Date: March 13, 2020
To: File
From: Richard Tuohey – Technical Services Superintendent Eagle Gold Project
Subject: 2019 Engineer of Record Summary Report for the Eagle Zone Open Pit

Date: March 13, 2020
To: File
From: Richard Tuohey – Technical Services Superintendent Eagle Gold Project
Subject: 2019 Engineer of Record Summary Report for the Platinum Gulch Waste Rock Storage Area (PG WRSA)

November 19, 2019
Project No.: 0792026

Re: Eagle Gold Heap Leach Facility – Annual Inspection

Figure 3-1. Piezometer P1 readings.

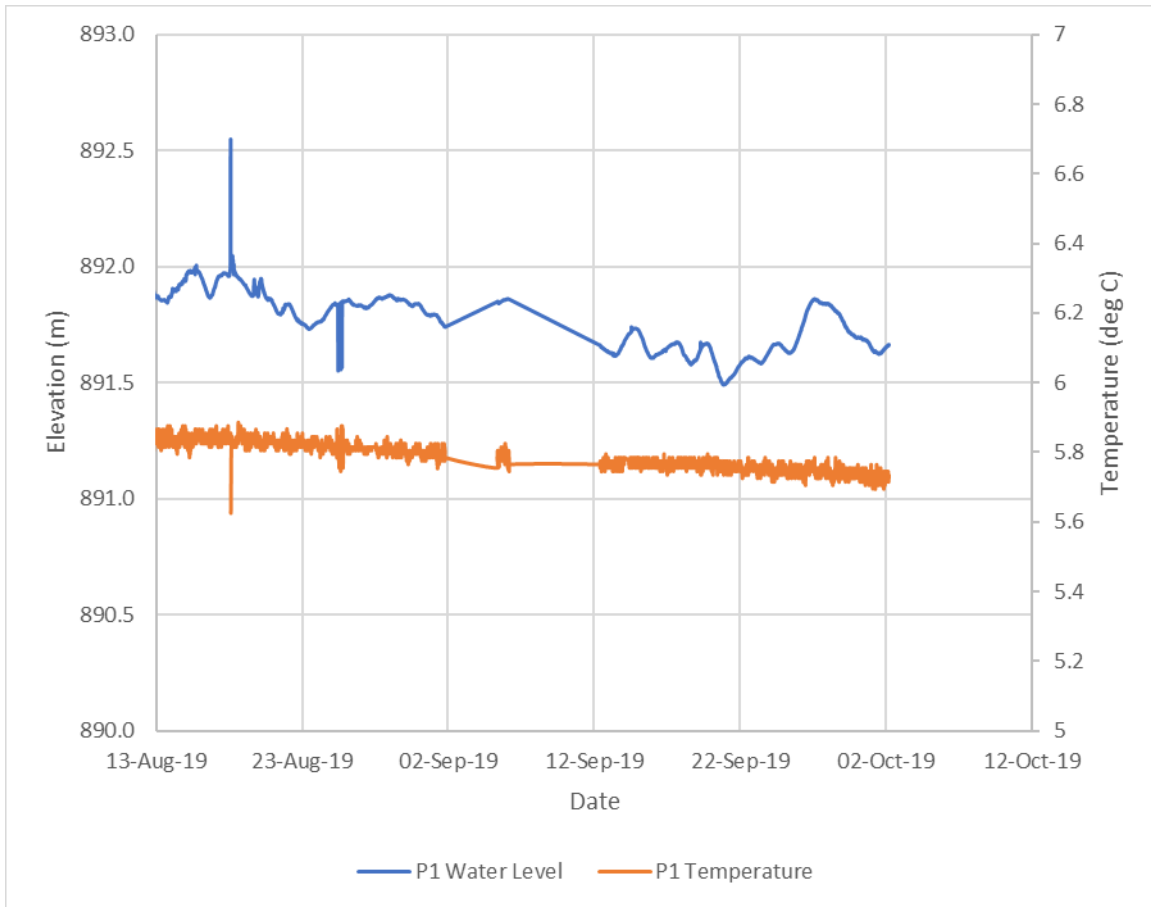
foundation bedrock and Piezometers P2 and P3 were installed in the dam fill just above the western and eastern underdrains, respectively. Piezometers P2 and P3 have been reportedly dry since installation. The water level in P1 reflects groundwater in the fractured and weathered bedrock foundation. The well log for P1 indicates a bedrock contact elevation of about 899.5 m. The water level readings since mid-August for P1 are presented in Figure 3-1 and reflect a general downward trend.

Photo 10. HLF underdrain outlet into monitoring vault looking east.

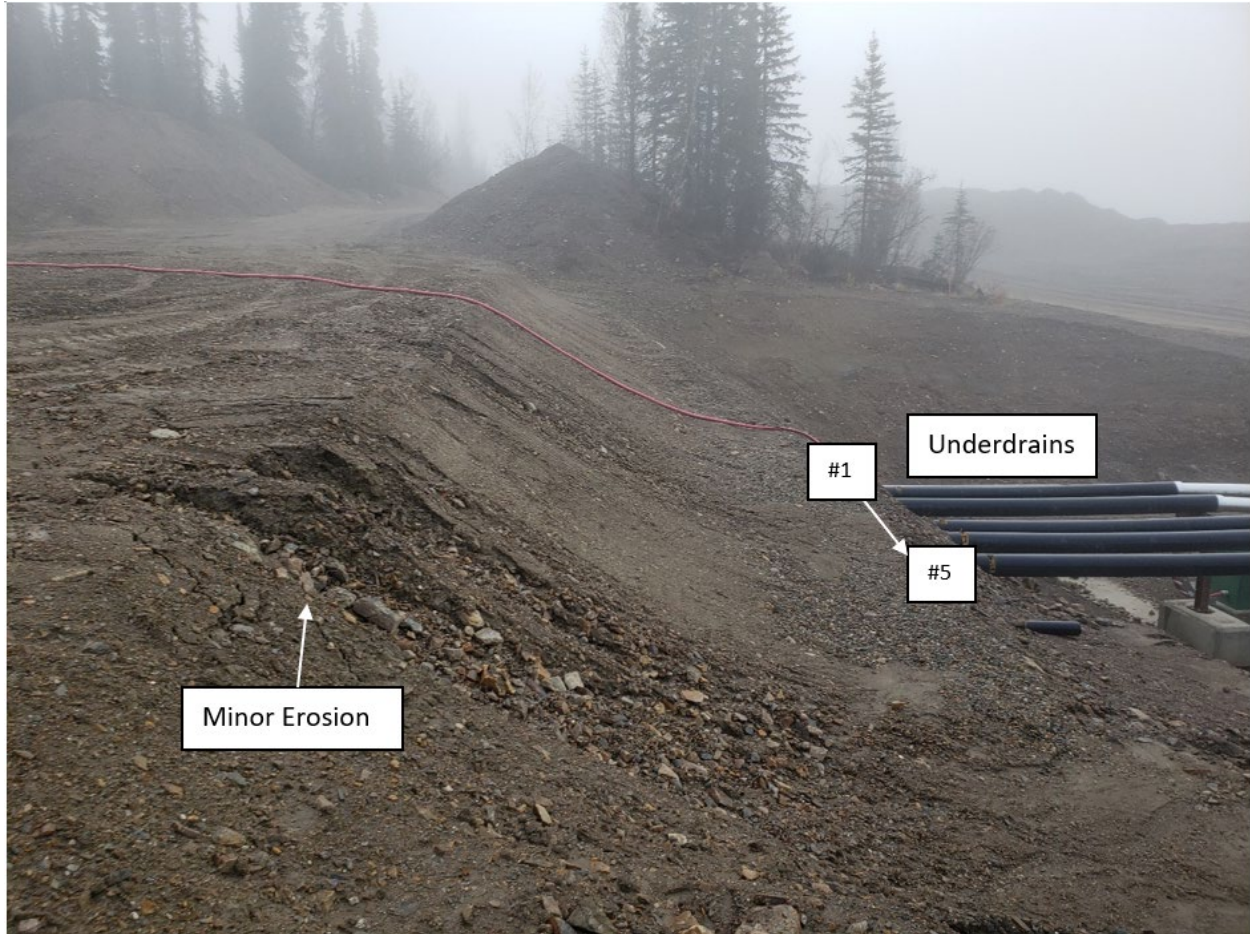
At the time of the visual inspection, water was not being discharged to the environment from the HLF underdrain flows but was being pumped back into the process circuit. Flows were apparent in underdrains #1, 2 and 5 which collect seepage under the Phase 1 HLF. No discharge was observed from underdrains #3 and 4, which are blank pipes installed in reserve for future phases of the HLF. The underdrain pipes are numbered from east to west (Figure A2 and Photo 11).

Photo 11. HLF underdrain outlet between dam and monitoring vault looking east.

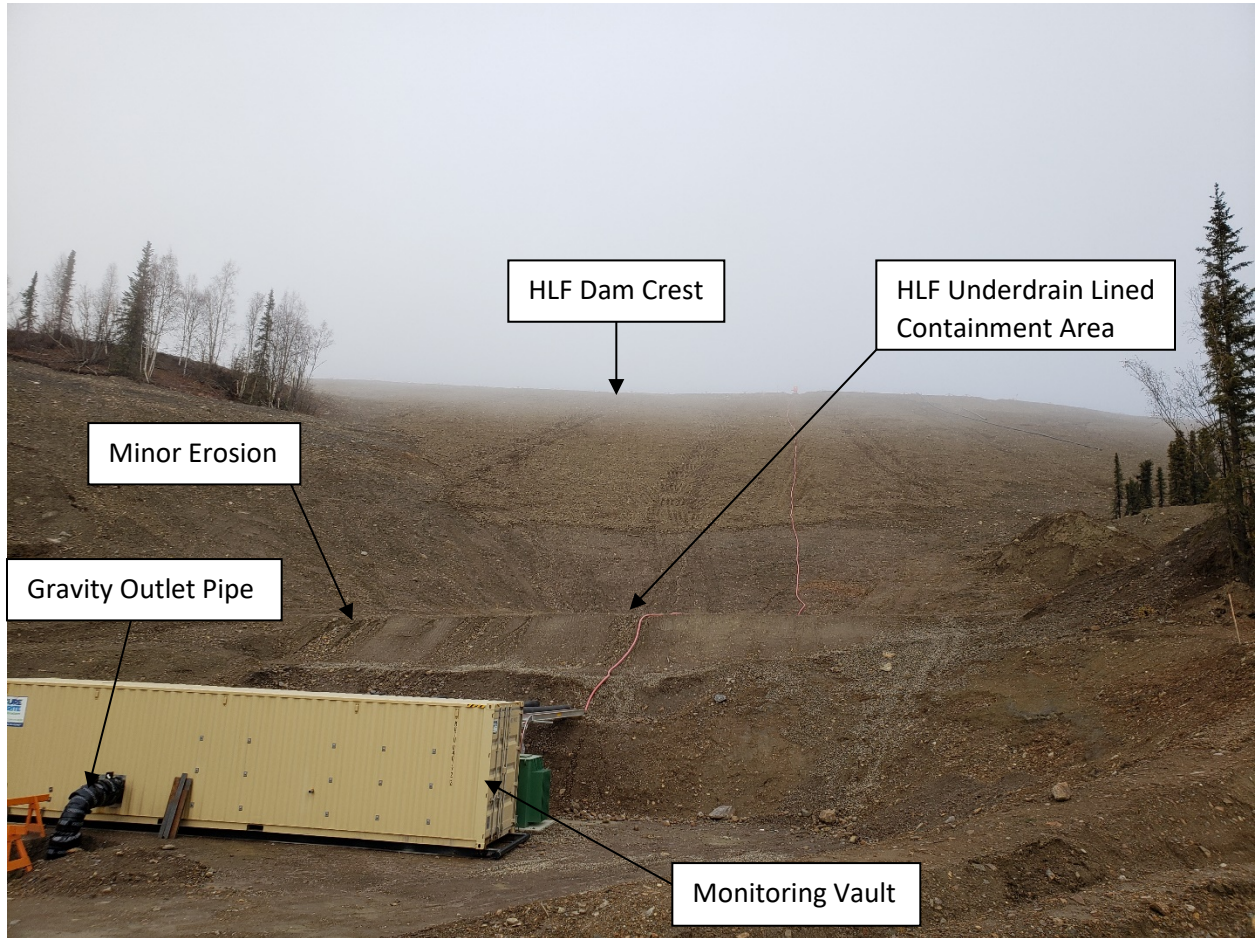
No.	Item	Status	Notes
1	Event Pond permanent pump installation	Complete	Tsurumi LH675 on wheeled skid
2	Completing casing stickup on three standpipe piezometers on the embankment crest and installation of vibrating wire instruments.	Complete	See Photo 23
3	Pad cell piezometer installation.	Pending	See Drawing EGHLF-XD-09-02 in BGC (January 8, 2018)
4	Instrument transmitter node post construction and placement in the field.	Partially Complete	Complete: Geokon Sensor Nodes at HLF Embankment and Event Pond Pending: Barometer and Sensor Node on HLF Pad
5	Instrument setup for continuous data download.	Pending	
6	Event Pond ballast selection and installation.	Pending	See Drawing EGHLF-XD-07-01 in BGC (January 8, 2018)
7	Installation of signage to mark underdrain discharge locations.	Pending	
8	Minor regrading of the north Event Pond perimeter road.	Complete	
9	Final tie-in of HLF underdrains to monitoring vault and frost protection of exposed pipes	Complete	See Photos 10 and 11

Photo 19. HLF Phase 1 Pad looking east from dam crest.

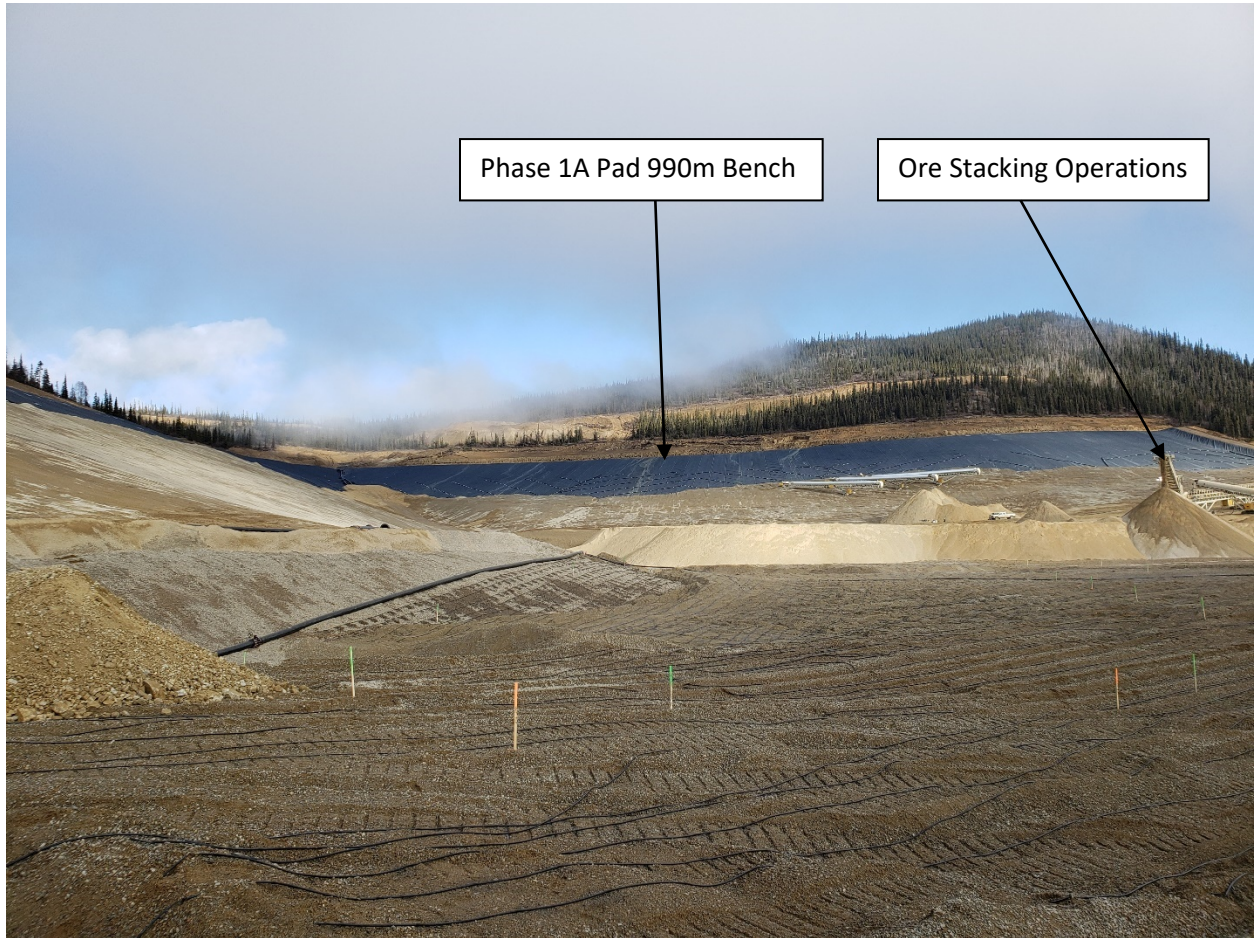
Based on discussions with SGC personnel, BGC understands the PLS pipeline, which is currently positioned on the HLF dam crest (Photo 19), will be repositioned down onto the ore at elevation 937.5 m in order to provide better containment and protection of the dam in case of a spill. BGC also understands that the ROM ore ramp placed near the western HLF dam abutment (Photo 21) will be regraded to provide more space between the fill and the spillway culvert entrance. BGC recommends a minimum 5 m setback to ensure free flow into the culverts. A 10 m setback is required between the dam crest and the ore pile toe per the construction documents (BGC, January 8, 2018).
